IBC - General

2019 GROUP B PUBLIC COMMENT AGENDA

2019 Public Comment Agenda

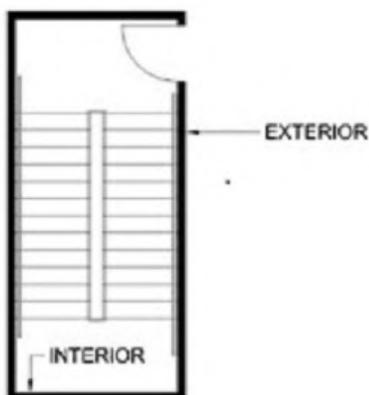
Reason: This proposal clarifies which side of these enclosure wall assemblies must be tested for abuse and impact resistance. 403.2.3.2 currently states that the exterior side is tested, but it does so in very confusing language. This proposal cleans that up and reiterates the point in 403.2.3.1. Also note that, due to the manner of construction of these enclosure wall assemblies, testing from the exterior side represents the worst case. This proposal also cleans up 403.2.3.4, which currently implies that 403.2.3.1 and 403.2.3.2 both apply to hard body impact testing, which is not the case. The first section is for soft body impact testing. This is simply a grammatical revision that clarifies the intent of the section.

For clarification, the exterior side is the side which does not face into the enclosure, as the figure below illustrates.
